Honda Motor Co., LTD has announced a safety recall campaign for certain 2005 Civic Si vehicles.

Applies To: 2005 Civic Si – From VIN SHHEP3...5U500001 thru SHHEP3...5U500345

Safety Recall: Civic Si Seat Belt Lower Anchors (Supersedes preliminary service bulletin 04-071, dated November 19, 2004)

Lower anchor bolt installation

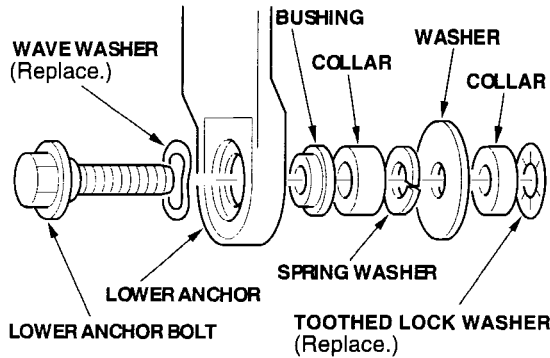
1. Check the movement of the driver's and the front passenger's lower seat belt anchors. The anchors should move smoothly back and forth without binding or sticking.
 - If both lower seat belt anchors move smoothly, go to step 9.
 - If either seat belt anchor binds or sticks, go to step 2.

- Remove the lower anchor cap and the lower anchor bolt. Keep the anchor bolt washers and collars in their exact order.

NOTE: The seat belt anchor bolts are installed with several washers and collars that must be kept in exact order for the anchor to work. Before you remove an anchor bolt, study the anchor bolt diagram carefully.

- Disassemble the anchor bolt, then discard the wave washer and the toothed lock washer.
- Reassemble the anchor bolt in the correct order with a new wave washer and a new toothed lock washer.
- Make sure there are no twists or kinks in the seat belt.
- Apply Hondalock 2 Threadlock to the anchor bolt threads. Reinstall the bolt by hand, and then torque it to 32 N·m (24 lb-ft).
- Reinstall the lower anchor cap.
- If needed, repeat steps 2 thru 7 on the other lower seat belt anchor.
- Center-punch a completion mark above the first character of the engine compartment VIN.

LOWER ANCHOR

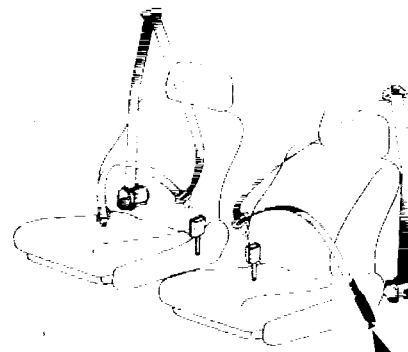
As soon as possible, check the movement of the driver's and front passenger's seat belt lower anchors. The lower anchors are between the seat and the door, bolted below the door (see the illustration below). Both anchors should move freely without binding or sticking. If either anchor binds or sticks, your vehicle needs to be repaired.
